TECHNICAL MEMORANDUM

Project No. 20446521-003-TM-Rev0-6000

DOMES DESIGN ISSUED FOR CONSTRUCTION DRAWINGS

PROJECT
WASTE ROCK DOME DESIGN
LUPIN MINE CLOSURE
NUNAVUT, CANADA

TITLE
PROPOSED WASTE ROCK DOME SECTIONS AND DETAILS

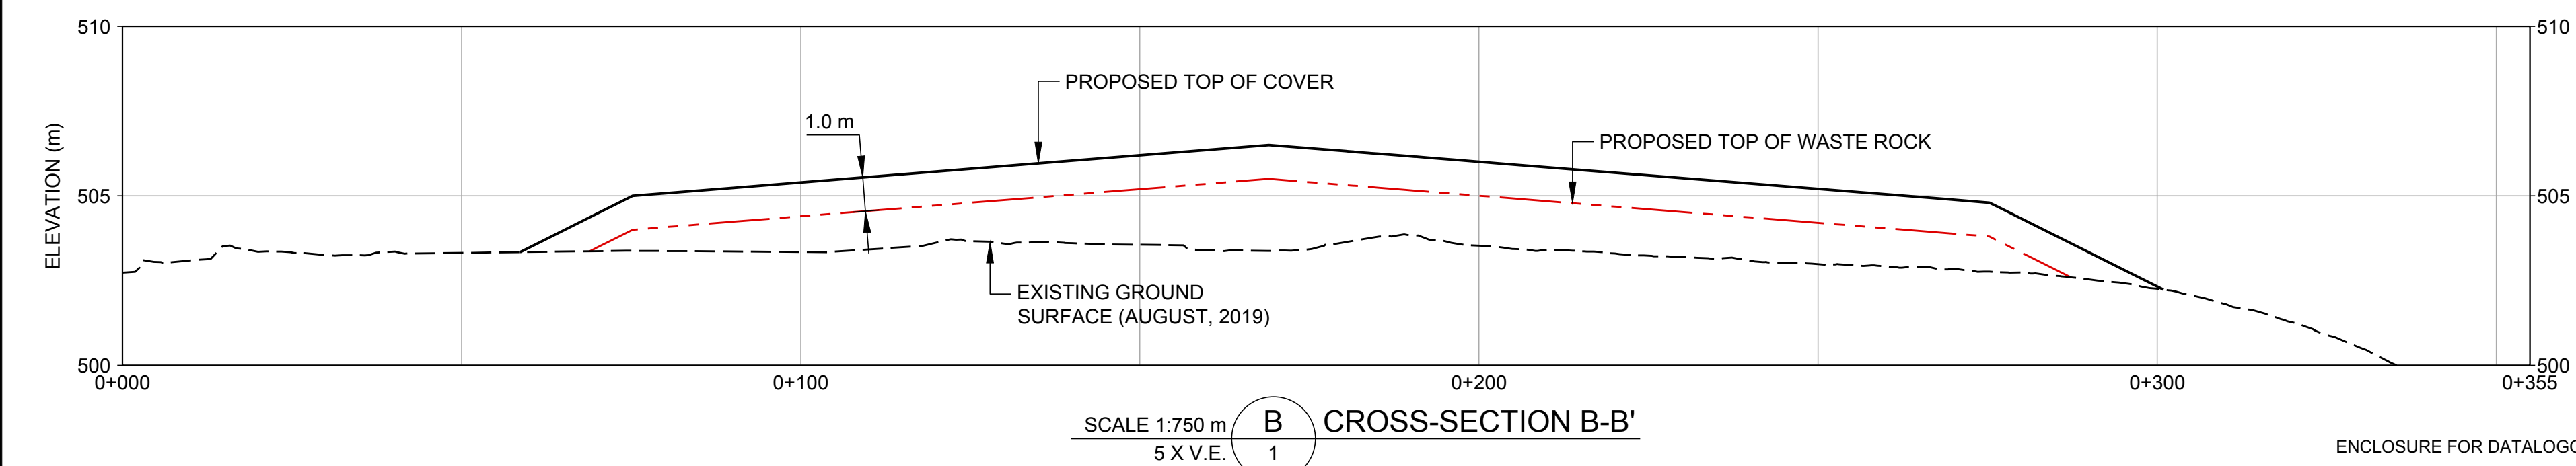
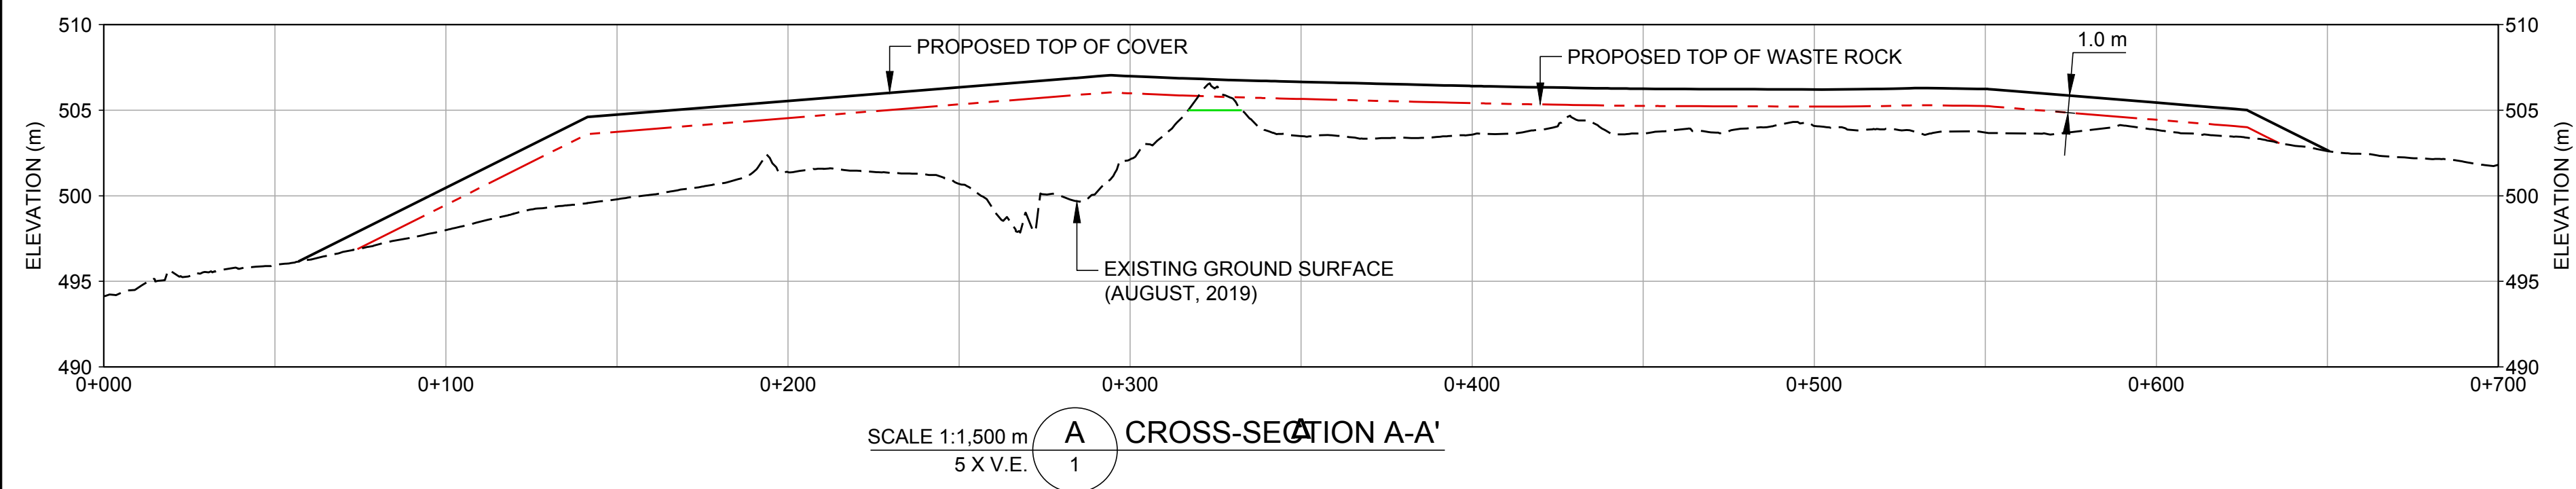
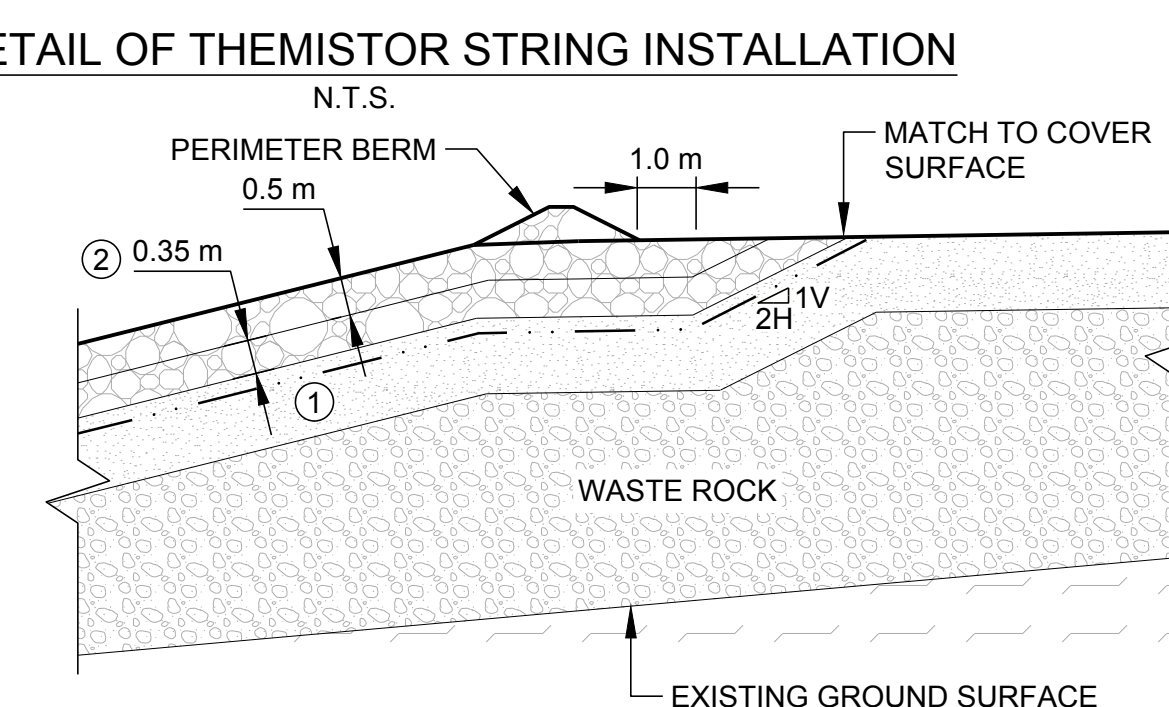
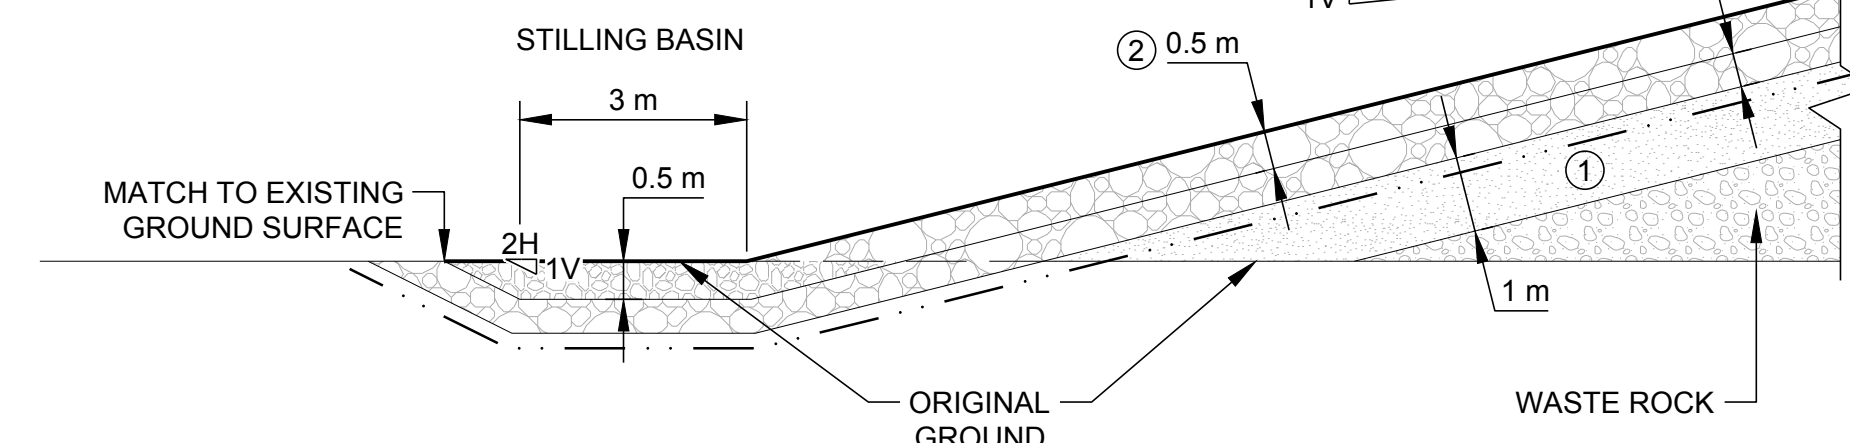
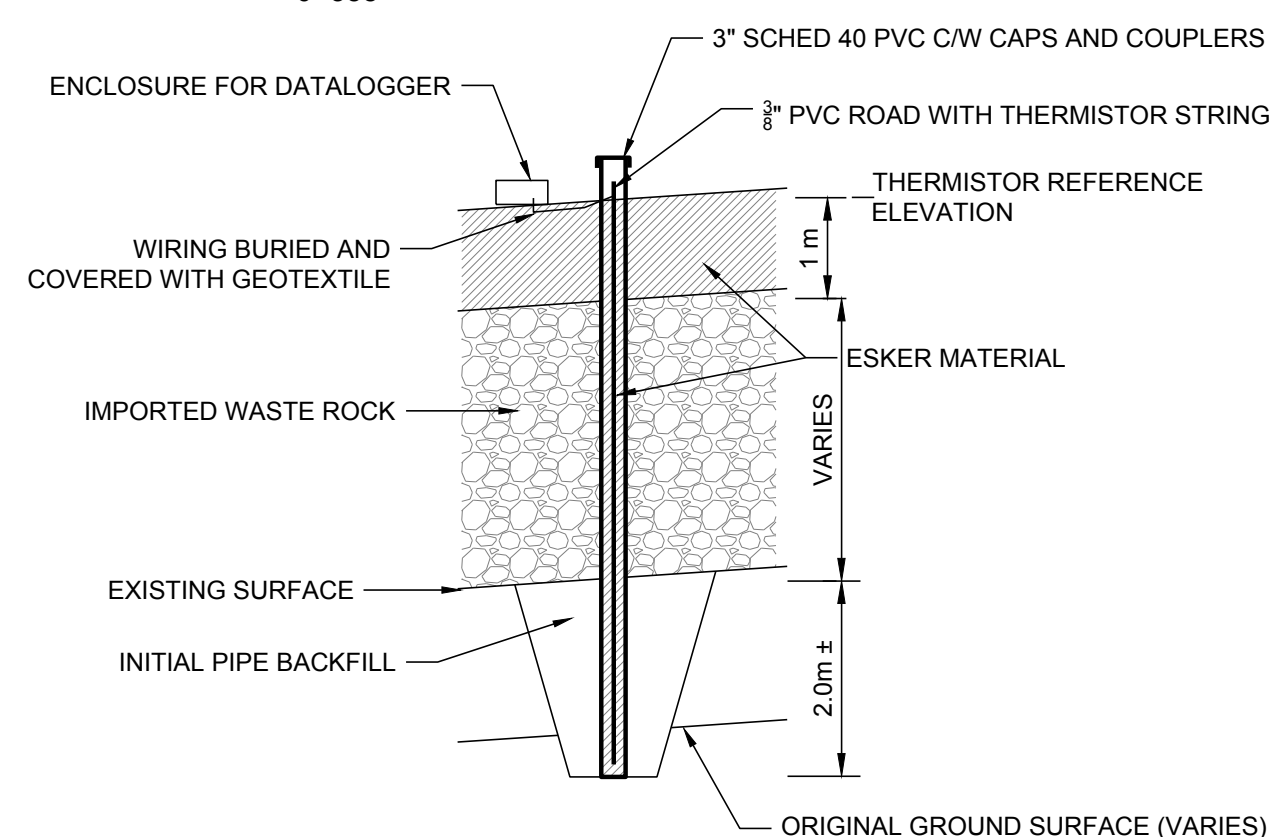
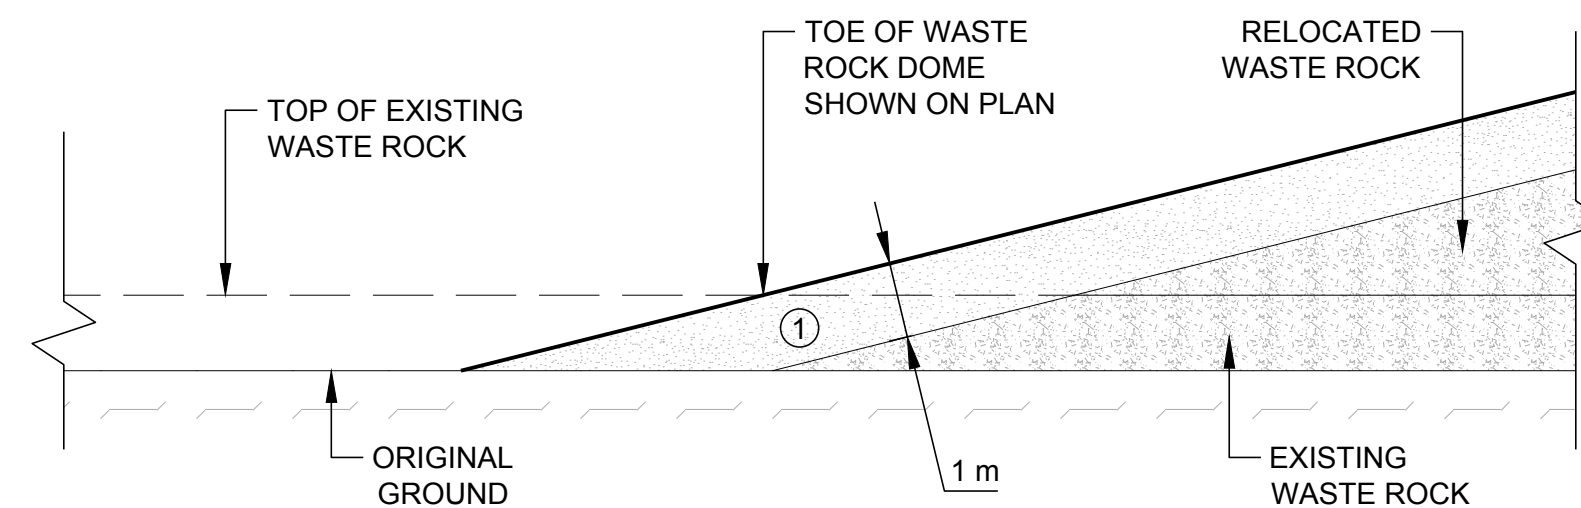
- b. lack of design information on storm / freshet flows;

- d. lack of runoff channels from discharge chutes;

- e. potential for toe erosion from discharge chute runoff flows;

In reviewing the typical drainage chute details, it appears to us that they are inconsistent as the 0.5 m depth of the drainage chute as shown in cross section is shown as 0.5 m berm on the top of the chute drainage profile detail and the perimeter berm is not shown on this detail. A plan view detail of the top and bottom of the drainage chutes should be provided.

The six chutes were hydraulically designed to each accommodate conservative discharge flows in excess of 1 m³/sec.

Each discharge chute will have a stilling basin at the toe to safely dissipate the flow energy. Flow exiting the stilling basins will be low velocity sub-critical flow which will flow over the cleaned natural ground surface, from which any existing waste rock has been removed. The natural ground surface is expected to comprise either bedrock or glacial till.

This has been clarified on Dwg. 19136158-0002-CM-0002_Rev 1, which also includes a section detailing the erosion protection at the entrance to each chute.

TITLE
PROPOSED WASTE ROCK REMOVAL AND PLACEMENT

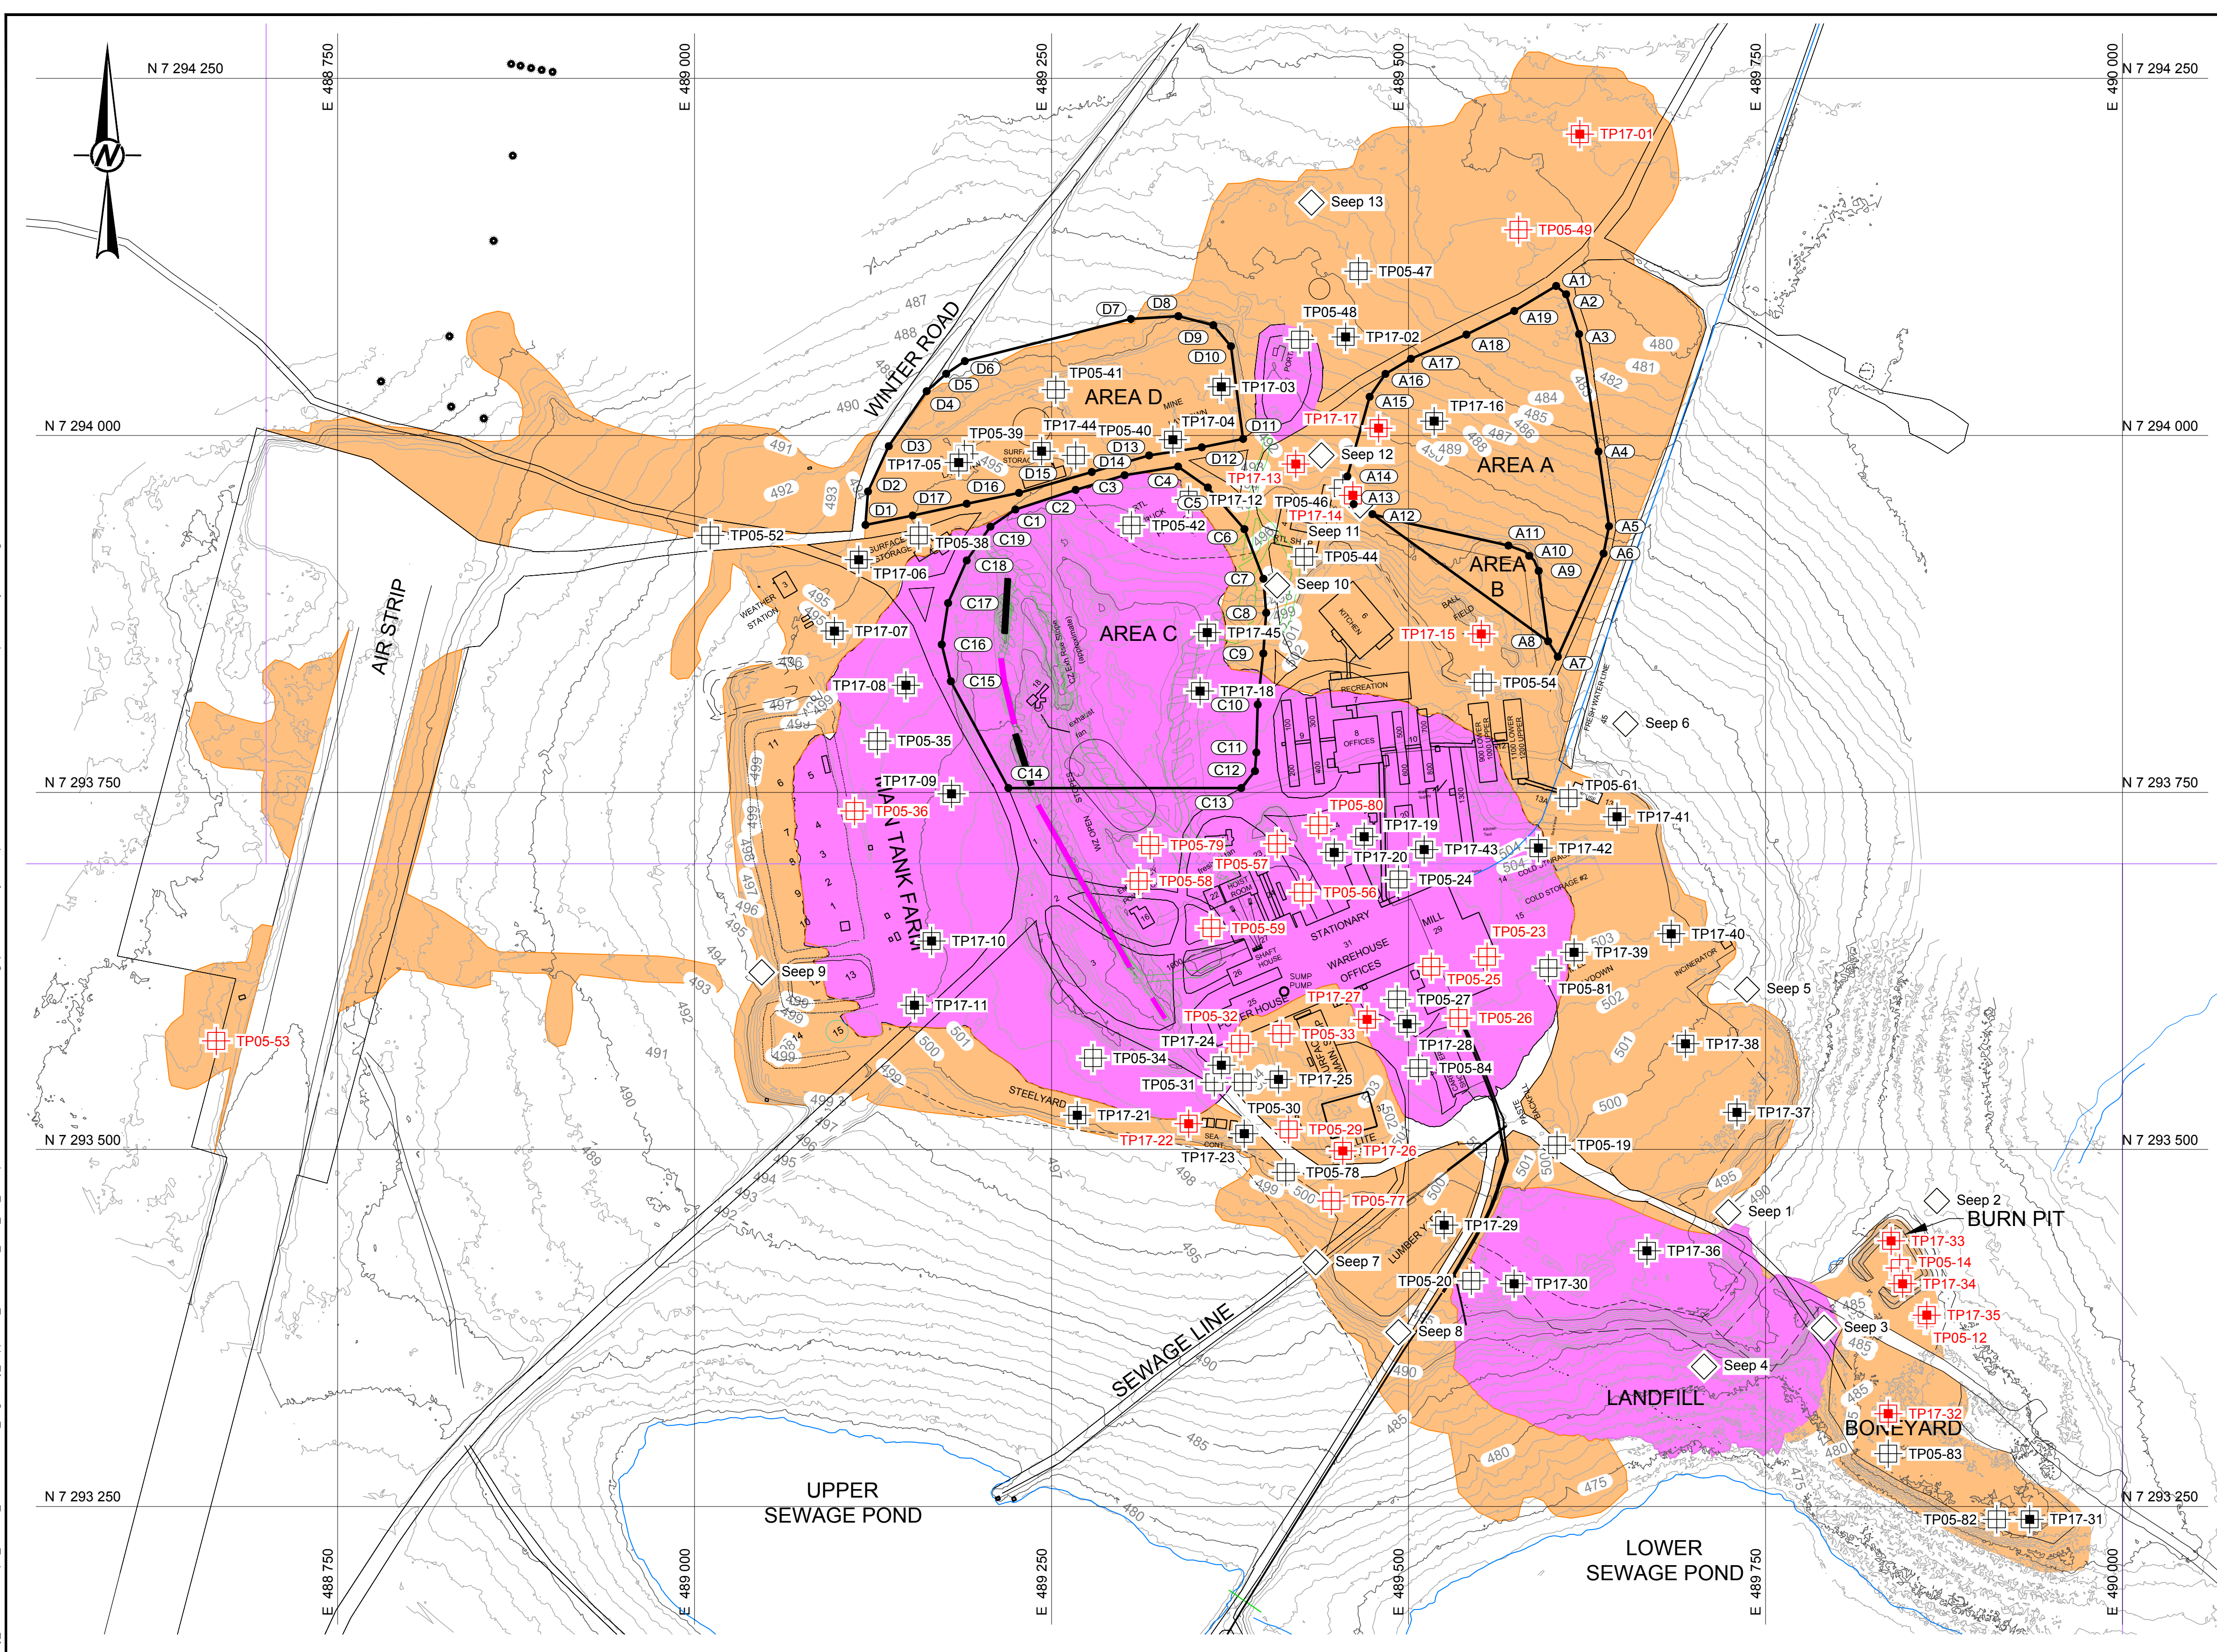
g. failure to show where materials to be removed prior to cover placement are located; and

Moreover, in addition to our specific concerns with the "dome" design concepts, we are also generally concerned that the remedial requirements that need to be undertaken are not specifically identified or referenced on the plan provided. We are concerned for example that in the absence of specific information on where contaminated soils to be removed are located, that confirmation that these soils have been removed may not be considered prior to reworking of the waste rock and placement of the esker cover. Provide specific cross reference to these works to ensure that they are identified in the FCRP and noted as appropriate.

The areas where known soil contamination is present are shown on a separate drawing: Dwg. 19136158-0005-CM-0001 Rev. D.

A copy of Dwg. 19136158-0005-CM-0001 Rev. D is attached. This shows the locations of all test pits where exceedances were identified in the two environmental site assessments (Morrow, 2006 and Golder, 2017). A copy of the August 2020 QA/QC Plan was provided to CIRNAC with LMI's technical responses to the updated FCRP on March 19, 2021. CIRNAC provided comments on the August 2020 QA/QC Plan to the NWB on April 8, 2021, and LMI responded to CIRNAC's comments on June 15, 2021. Furthermore, the QA/QC Plan (Lupin Mines Incorporated, 2021) was attached as Appendix C to the draft PCMP, which was submitted on April 8, 2021.
